# SANYO 6C-32

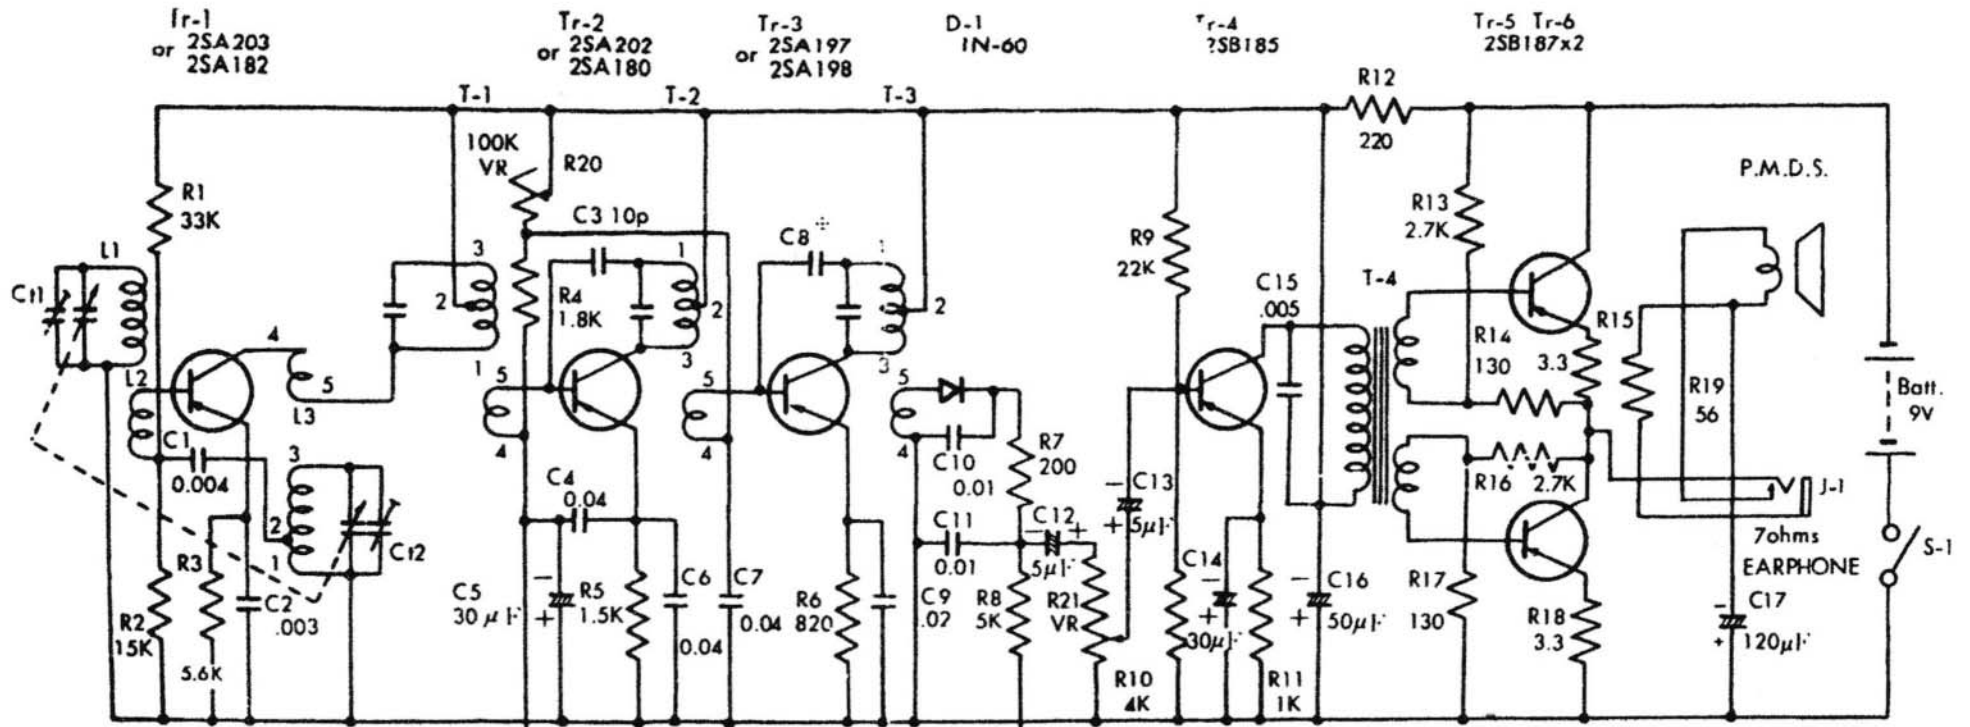
\* C8 7pF---2SA197or2SA198 (C<sub>c</sub>8pF-14pF) No.5  
 10pF---2SA197or2SA198 (C<sub>c</sub>14pF-18pF) No.6

CHANGE R10 4K → 6.8K  
 R14 3.3 → 4.7  
 R18 3.3 → 4.7
